**DOCUMENT 00 90 00  
ADDENDUM**

**ADDENDUM NO. [1]                      Date: May 7, 2019**

**RE:                      HOUSING AUTHORITY OF LA CROSSE  
2018-19 CAPITAL IMPROVEMENT PROJECTS  
1307 BADGER STREET  
LA CROSSE, WI 54601  
HSR PROJECT NO. 18065**

**E100**

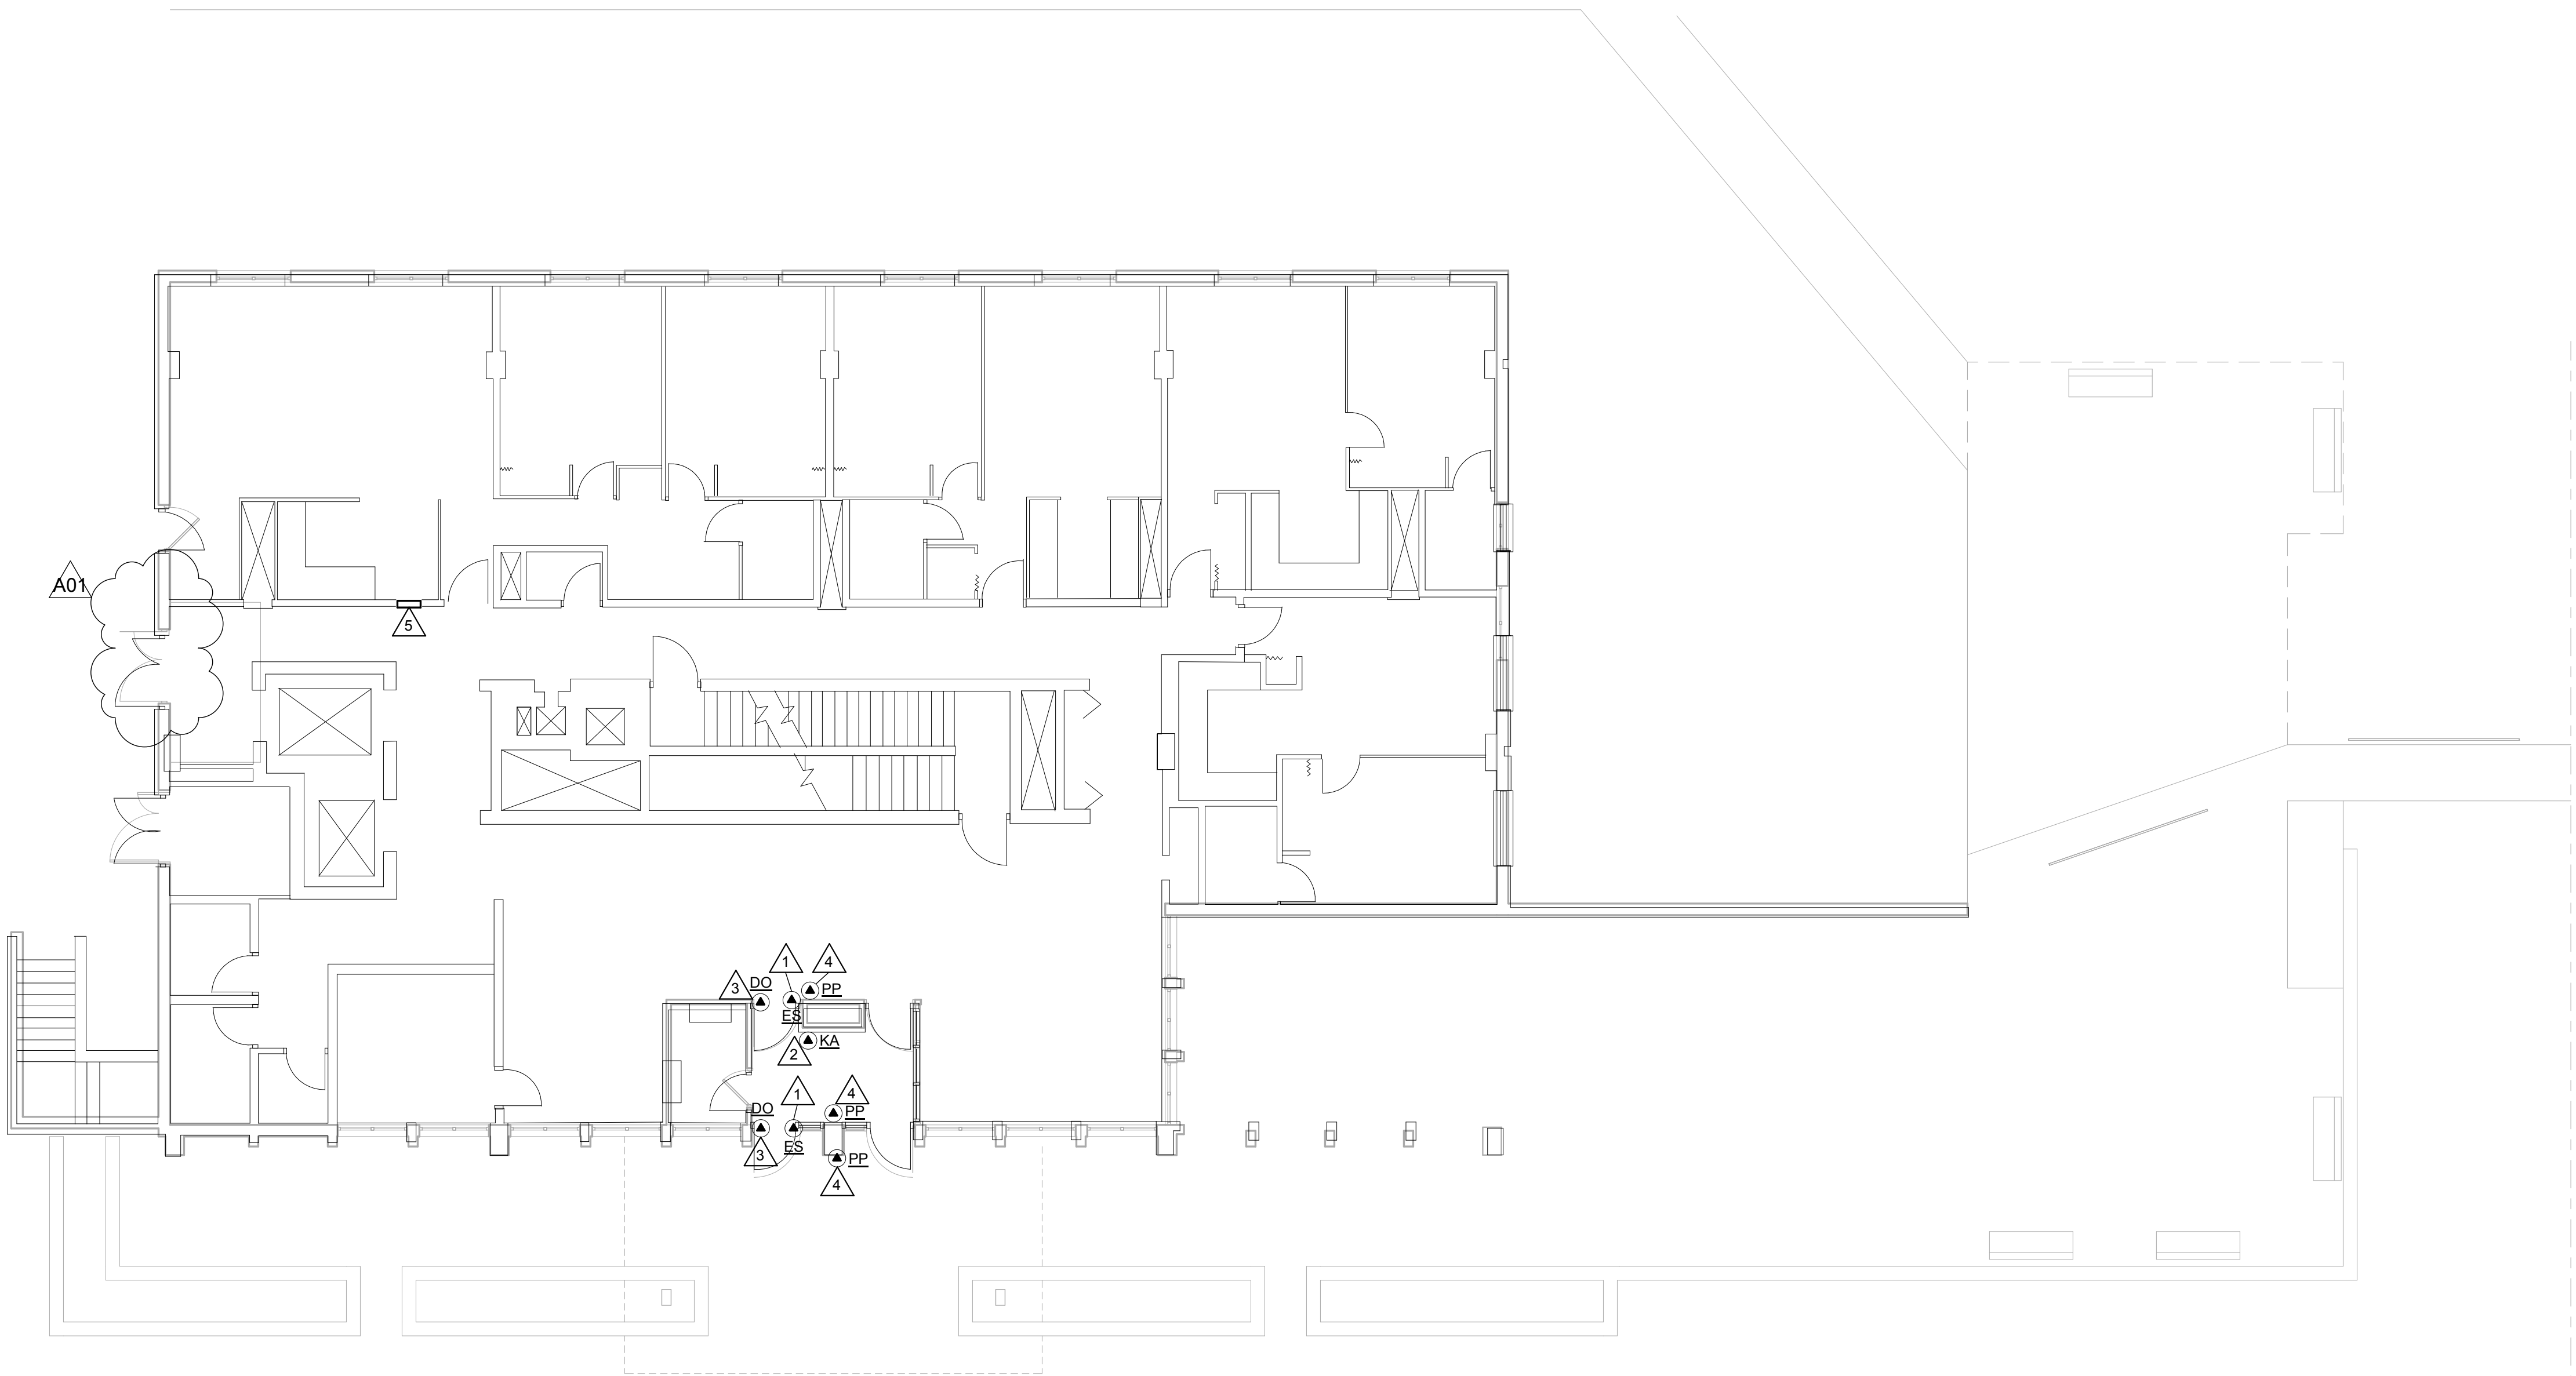
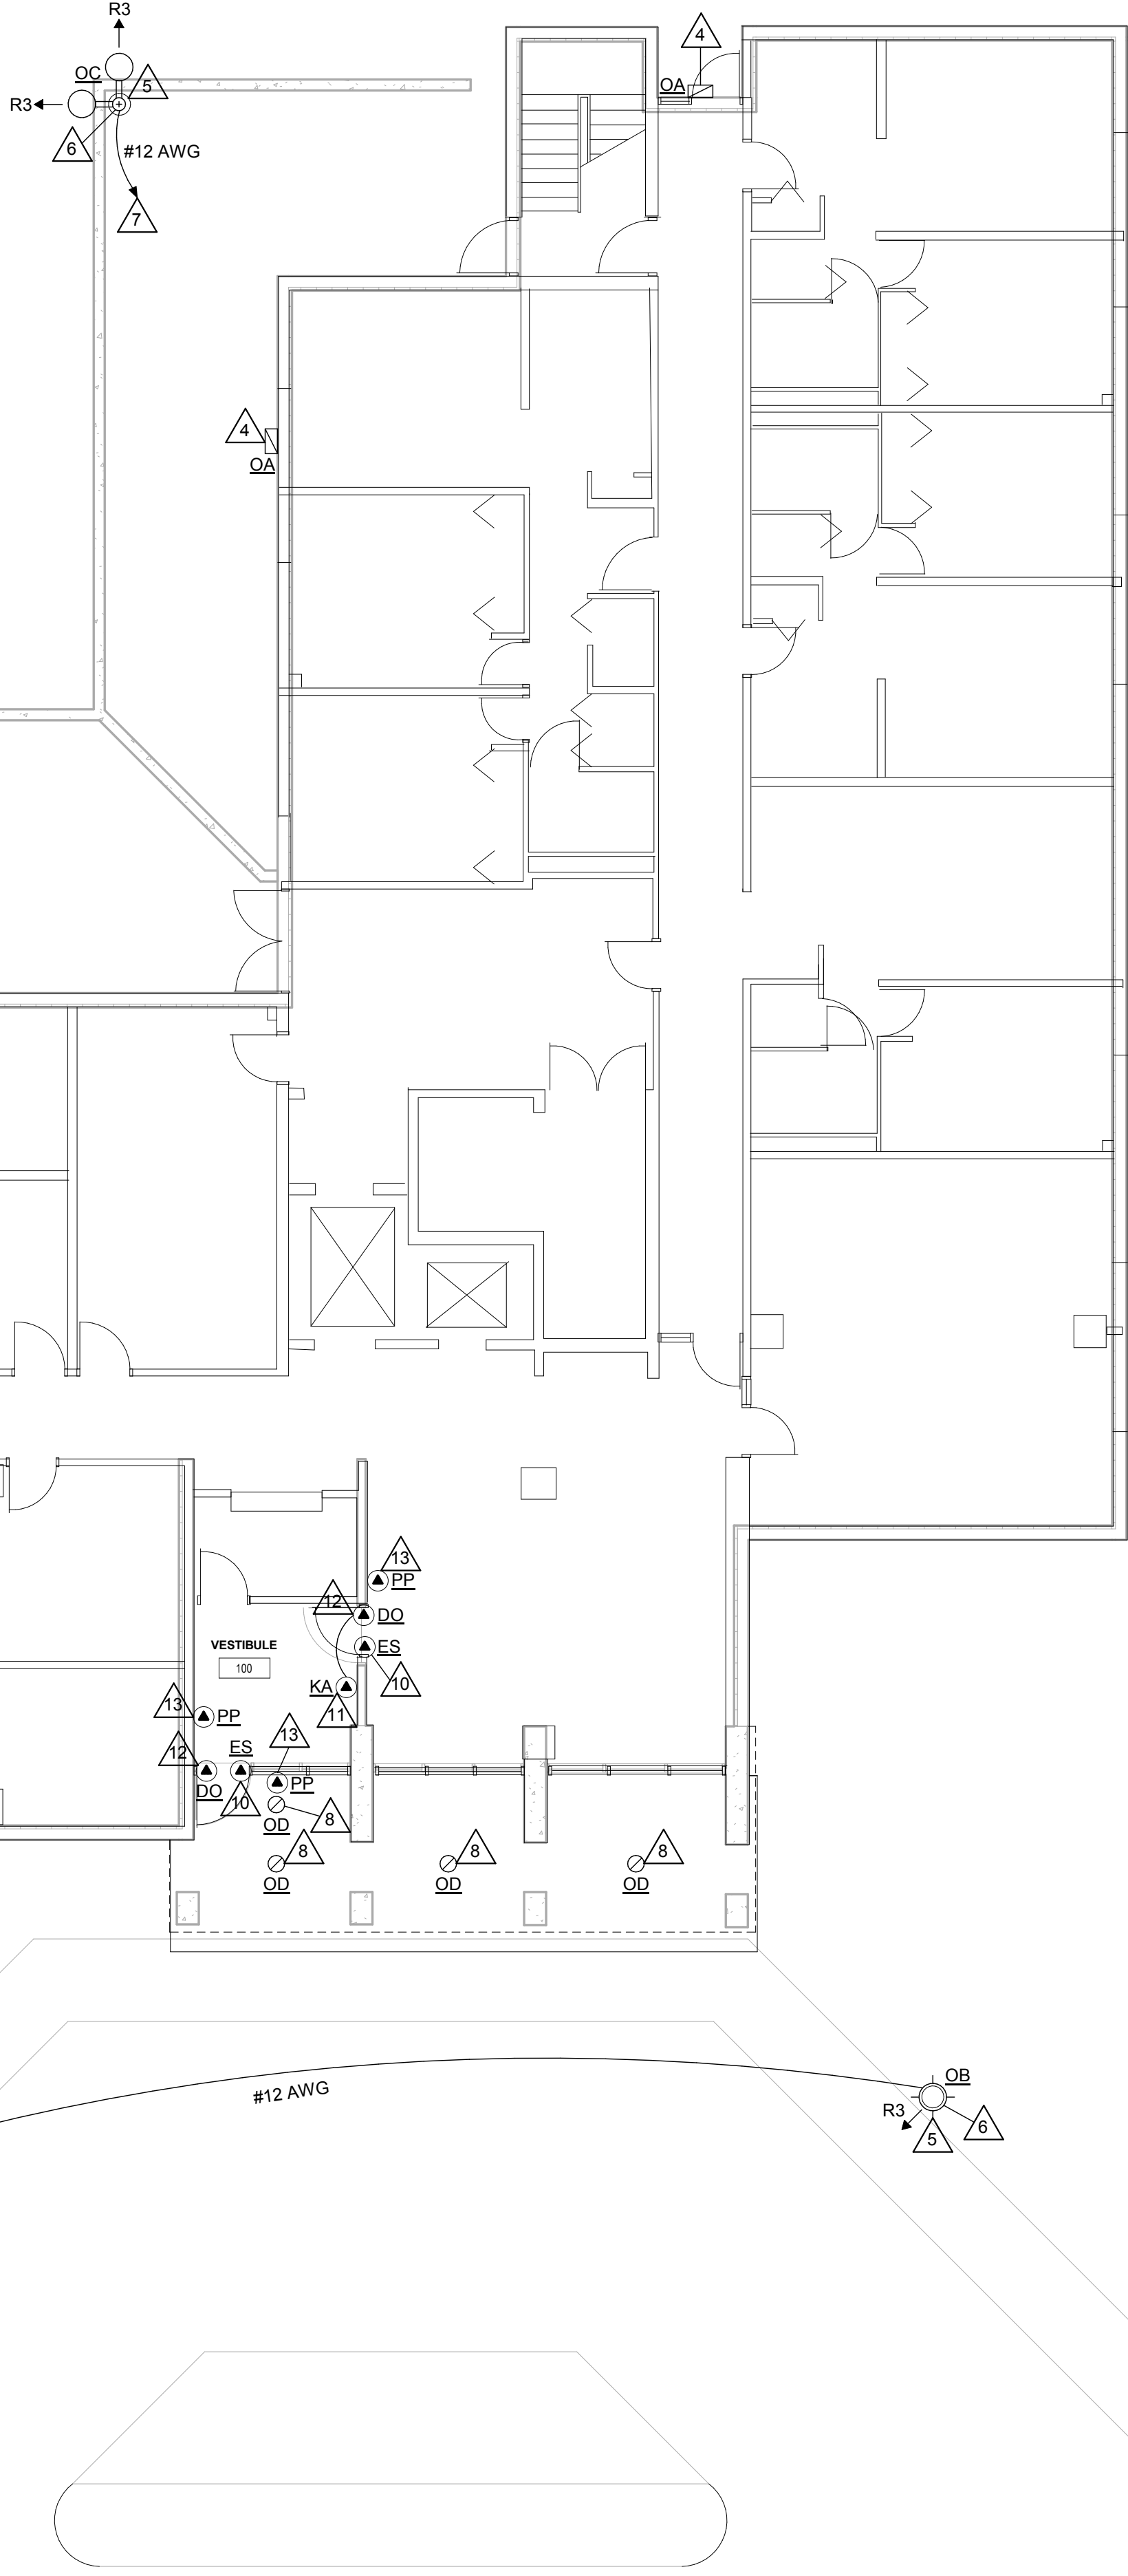
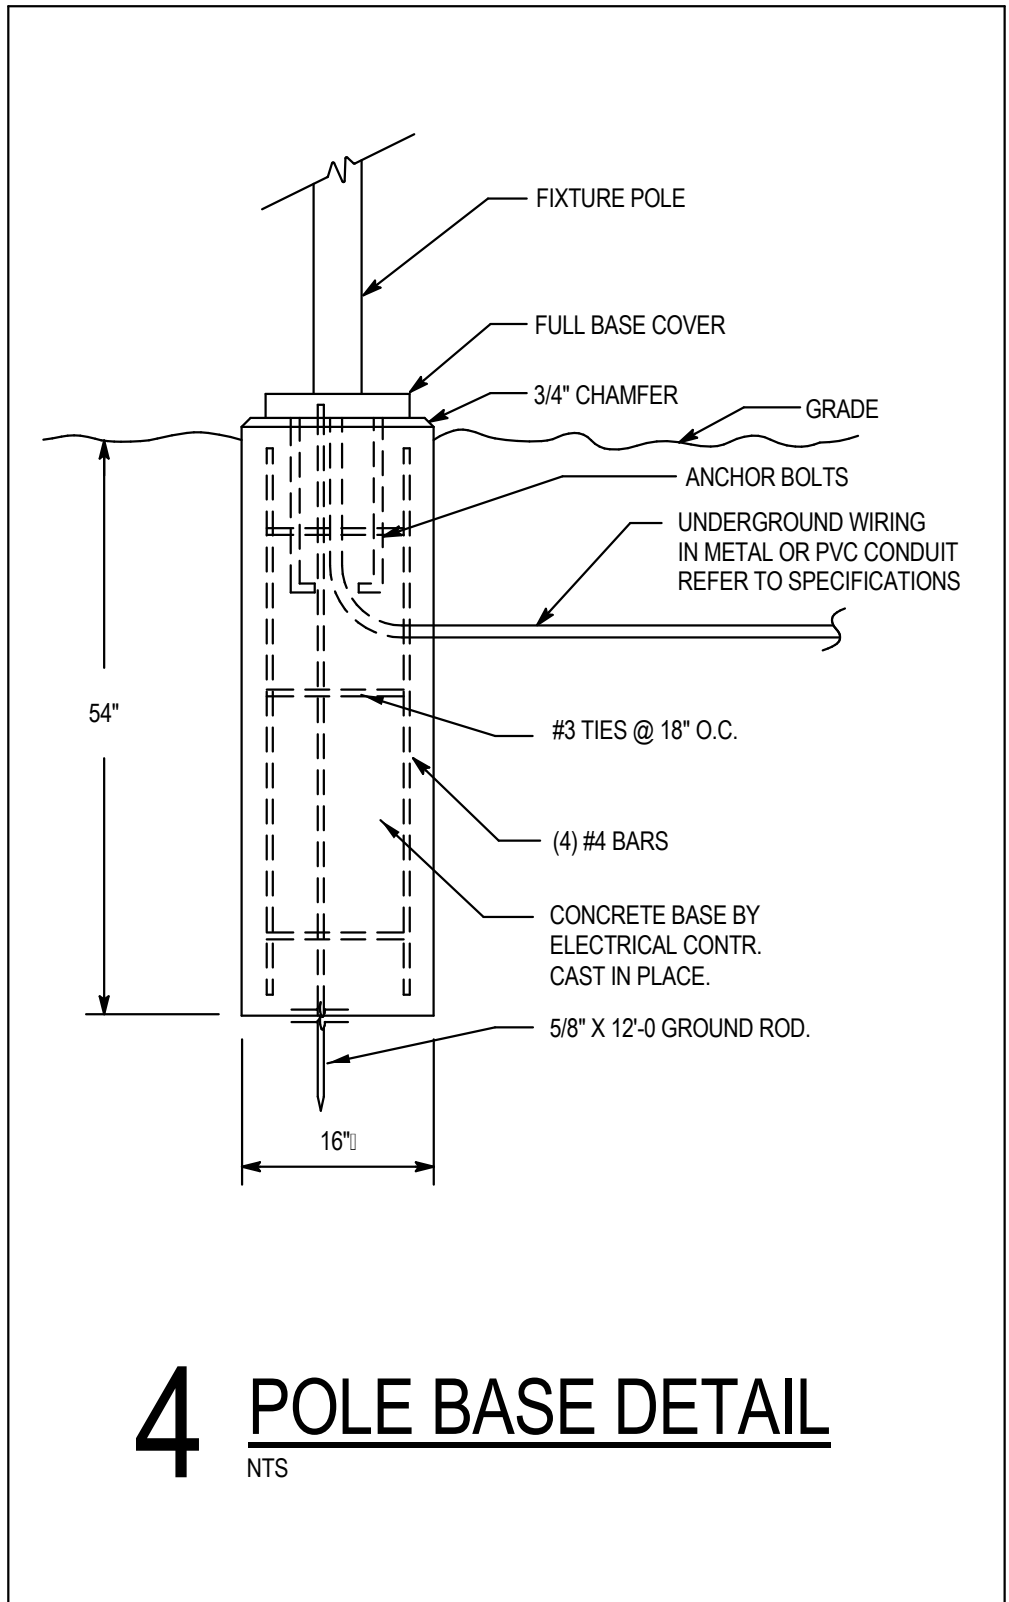
- c. All entry door frame dimensions shall be field verified prior to ordering doors.
- 9. Sheet E100 FIRST FLOOR ELECTRICAL PLAN – STOFFEL COURT 30 x 42 attached hereto

- a. Revisions clouded on Drawing
  - b. General Notes: See revised note D. See new note F.
  - c. Disregard all new power requirements at door hardware for North double door.

E300

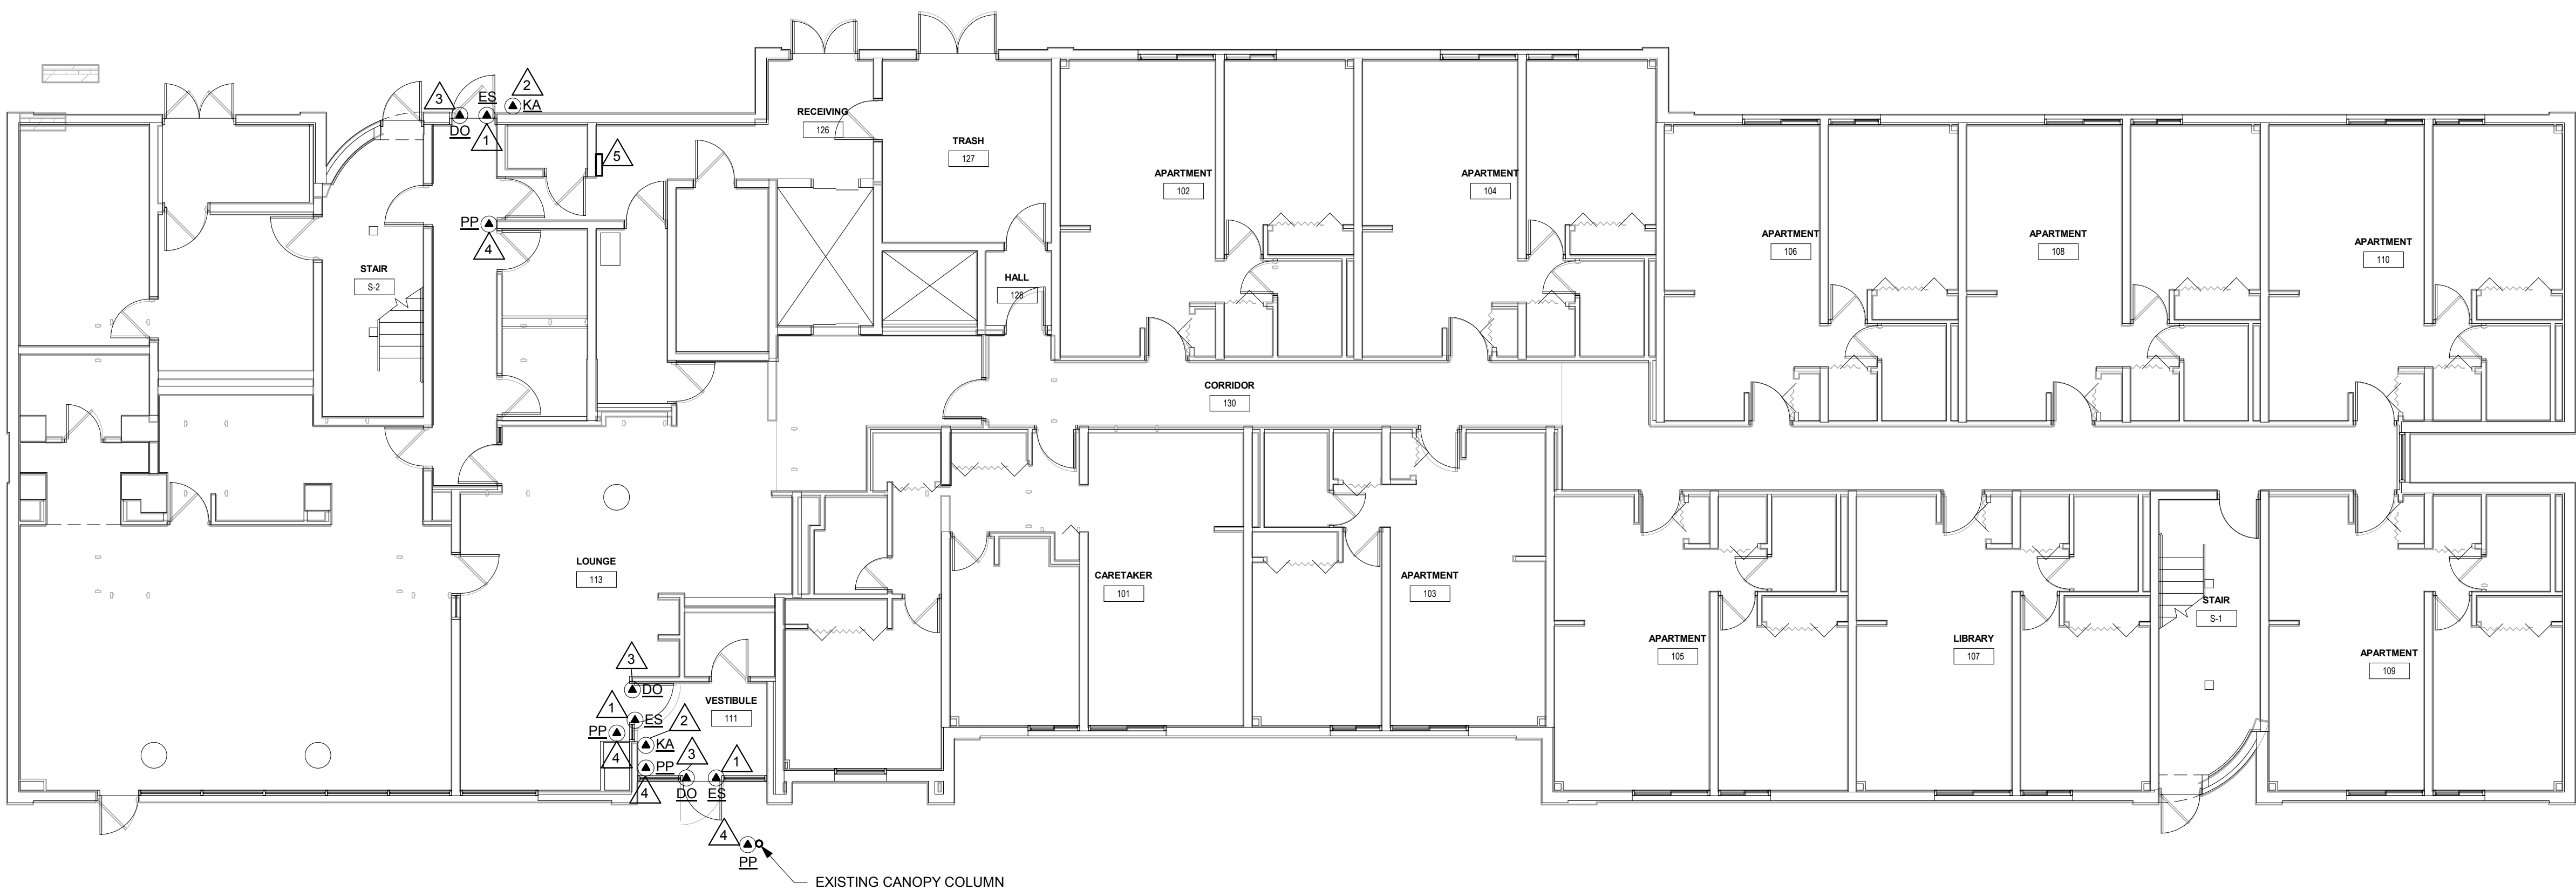
- 11. Sheet E300 ELECTRICAL FLOOR PLAN - SOLBERG HTS 30 x 42 attached hereto
  - a. Revisions clouded on Drawing.
  - b. General Notes: See revised note D. See new note F.
